# Spittal – Loch Buidhe – Beauly 400kV Overhead Line

Alignment Report on Consultation

January 2025

Figure 1: Potential and Alternative Alignment Options presented during consultation

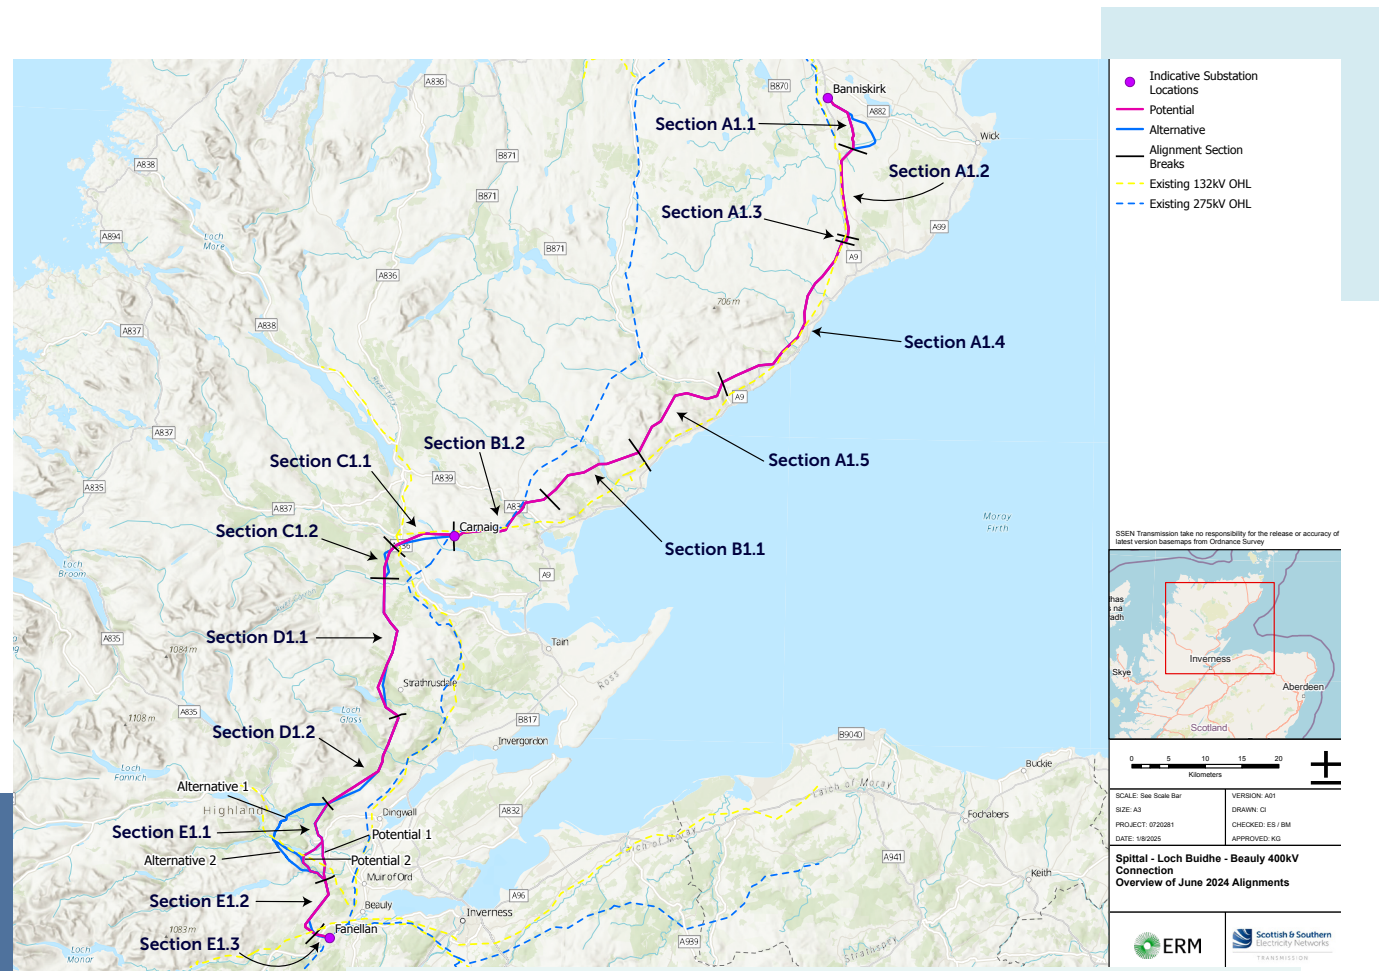
The consultation explained how we believe the Potential Alignment, shown in pink in Appendix B, offers the best balance of technical and environmental impact considerations identified through internal assessment and previous public and statutory consultation on route options. This was then subject to further consultation with stakeholders, where local and previously unknown considerations may confirm or alter the initial preference.

Figure 2: Overview of Proposed Alignments

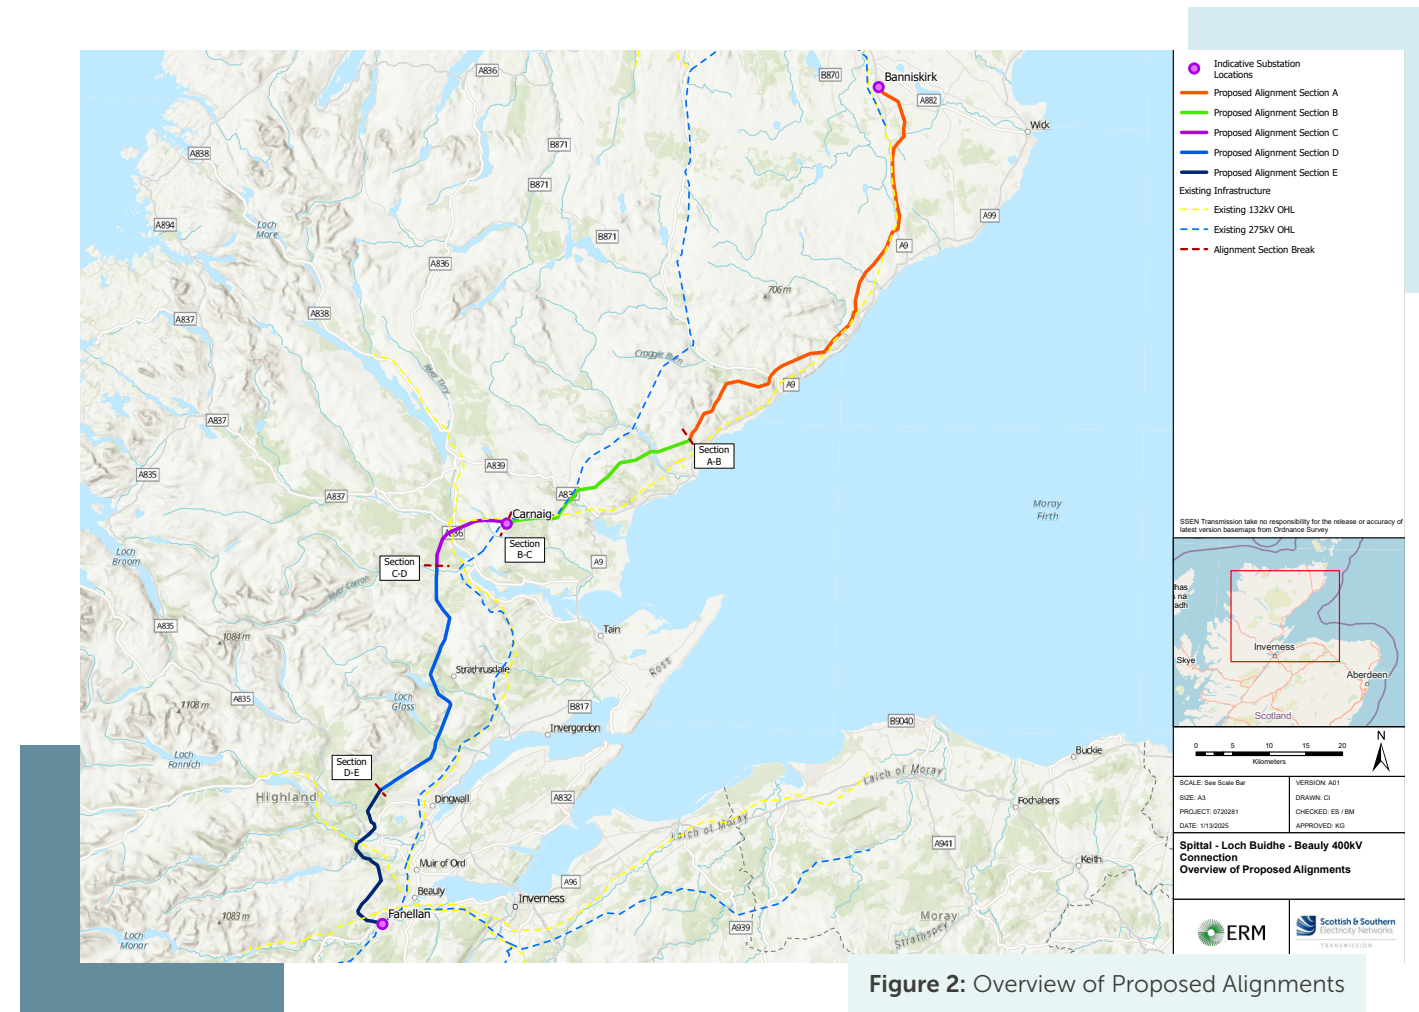
Potential Alignment E1.2 is preferred over Alternative Alignment E1.2 when considering both environmental and engineering constraints. Based on the feedback received, the Potential Alignment E1.2 was adjusted to avoid impacts on the schedule monuments northeast of the Breakachy Hill and to minimise impacts on watercourses south of Breakachy Hill.

Potential Alignment E1.3 is preferred over Alternative Alignment E1.3 when considering both environmental and engineering constraints.
